Re: Initial Submission Review – Waterstone Site Plan No 4 – Site Plan and Plat
Application Number: **DA-1758-10**
Case Numbers: **2021-4016-00**

Initial Submission Review

Waterstone Filing No. 4
City of Aurora, Colorado
Drainage Plan
Historic Drainage

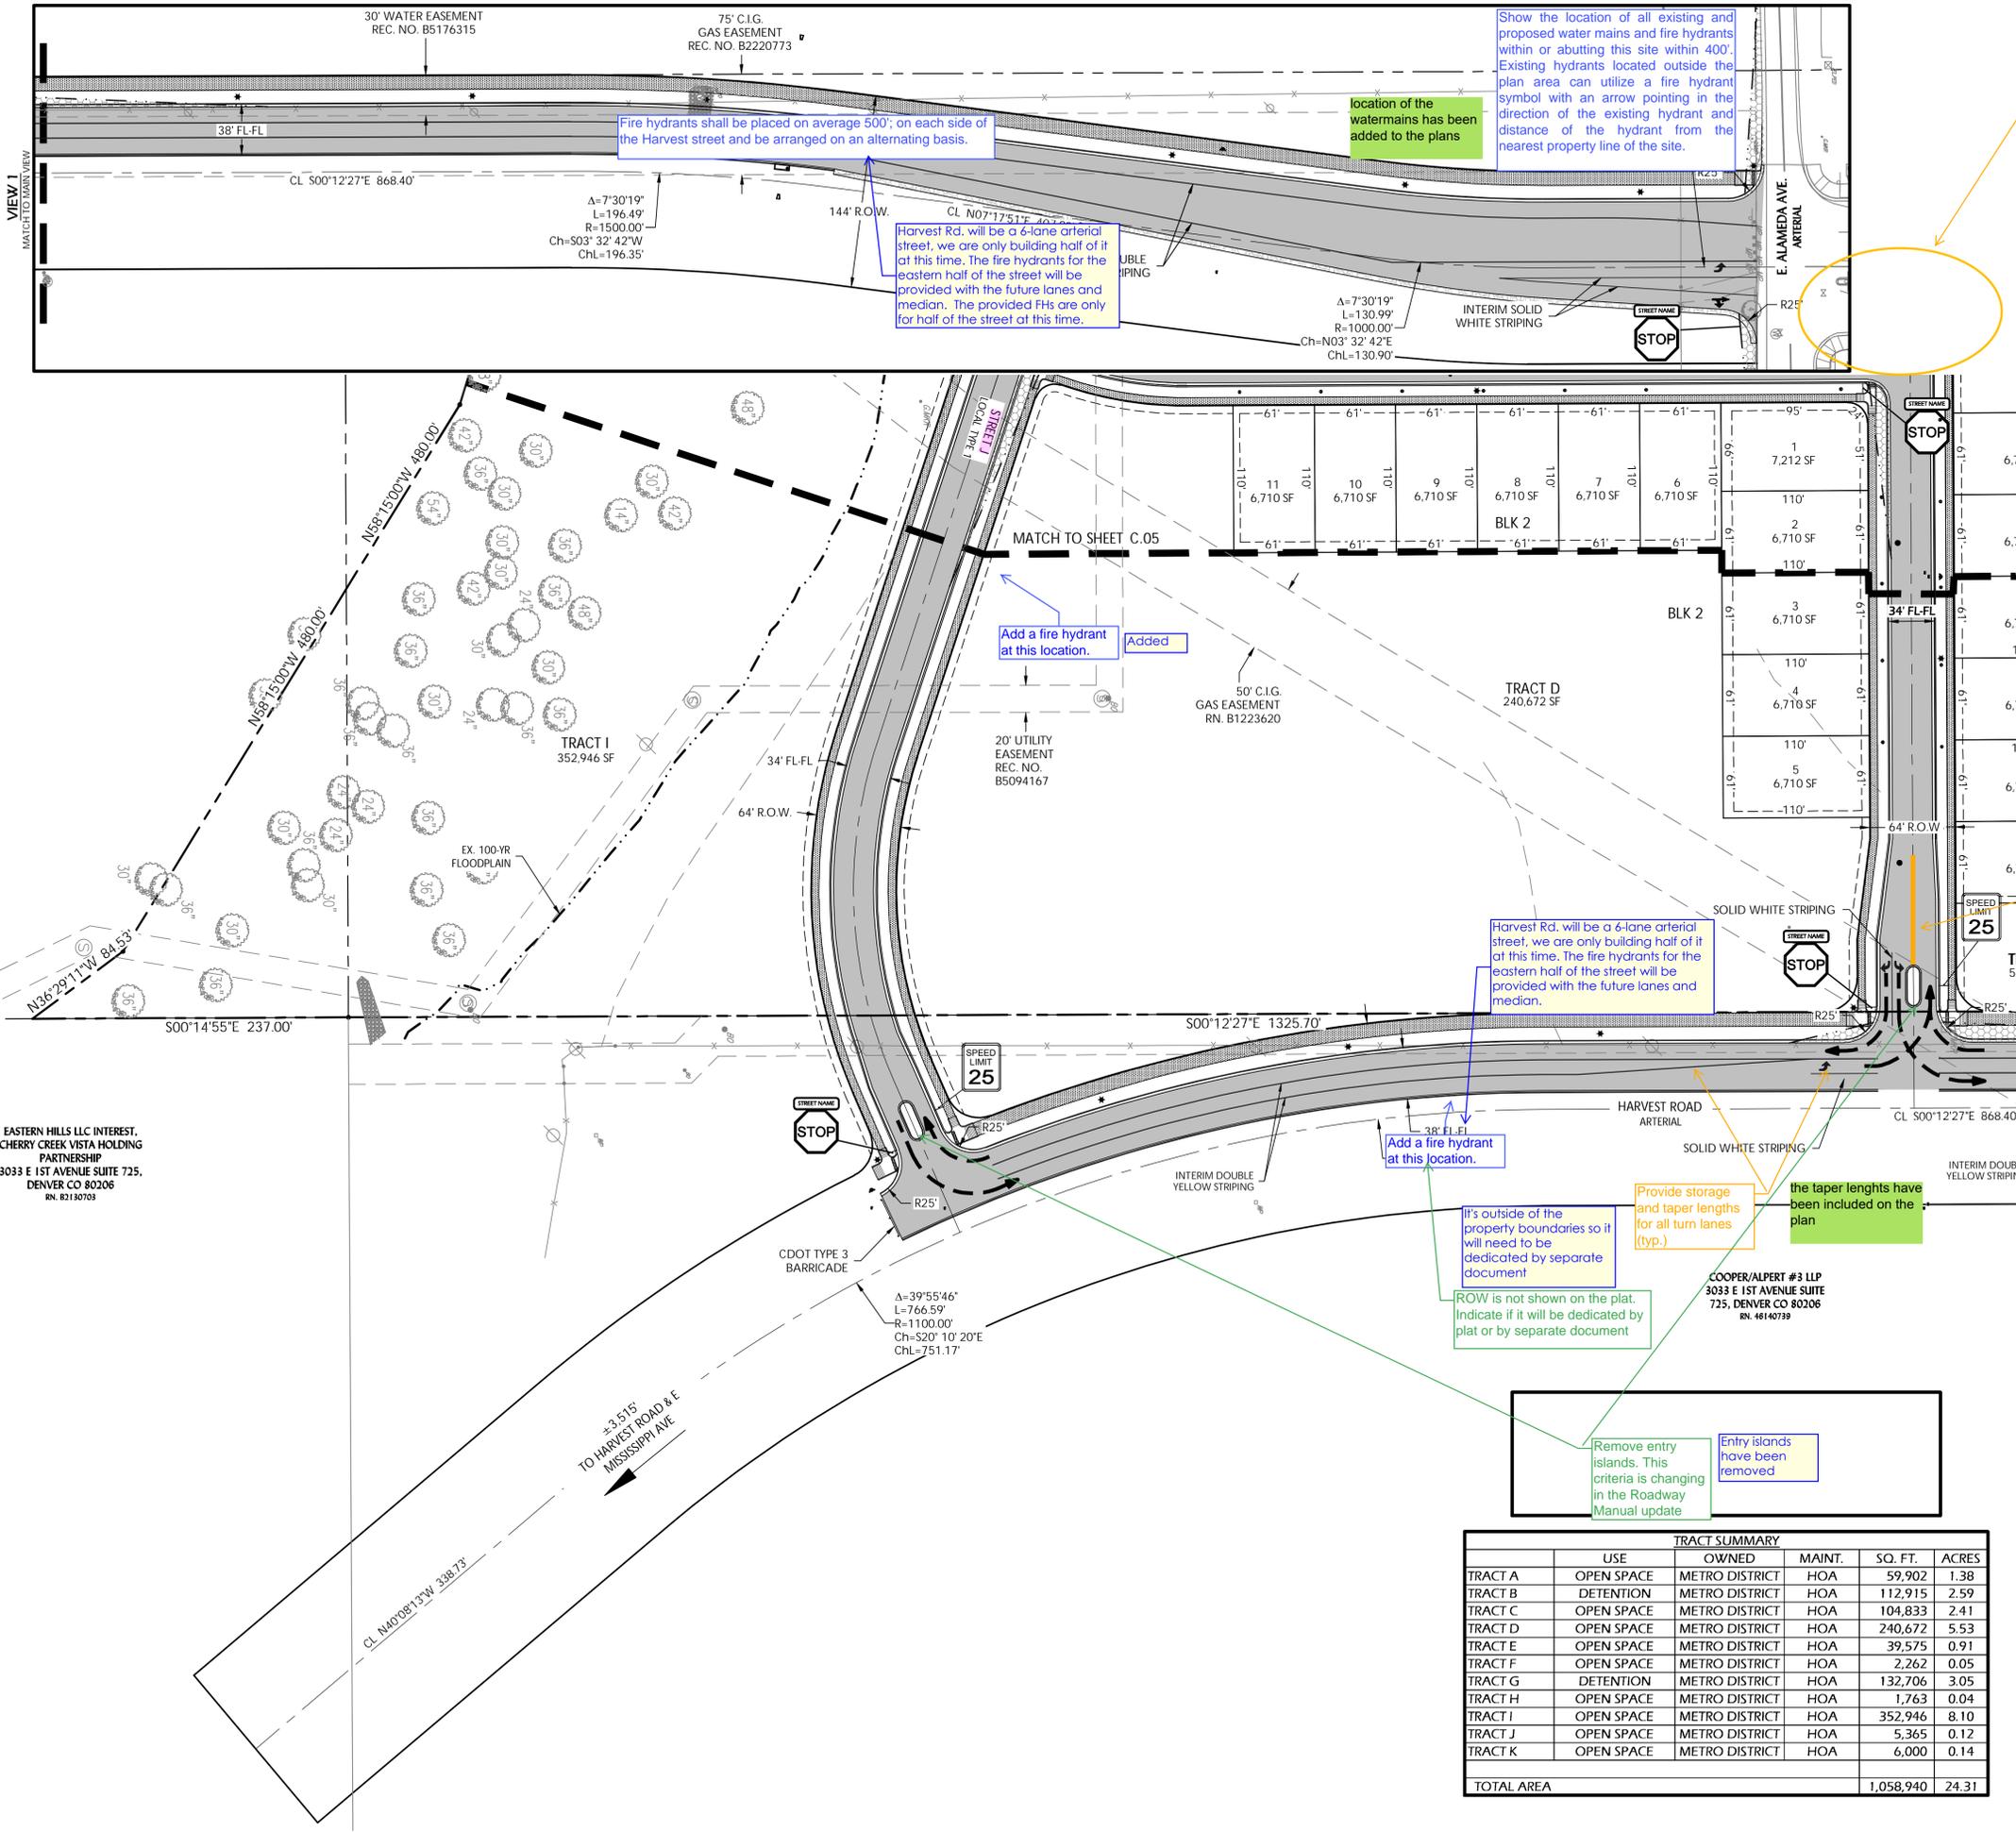
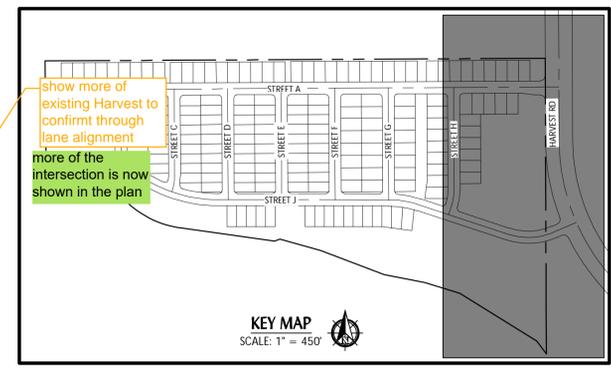
Add a fire hydrant at this location.

It's outside of the property boundaries so it will need to be dedicated by separate document
 ROW is not shown on the plat. Indicate if it will be dedicated by plat or by separate document

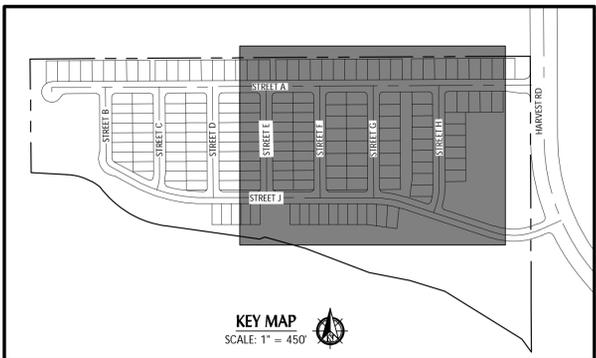
Provide storage and taper lengths for all turn lanes (typ.)

the taper lengths have been included on the plan
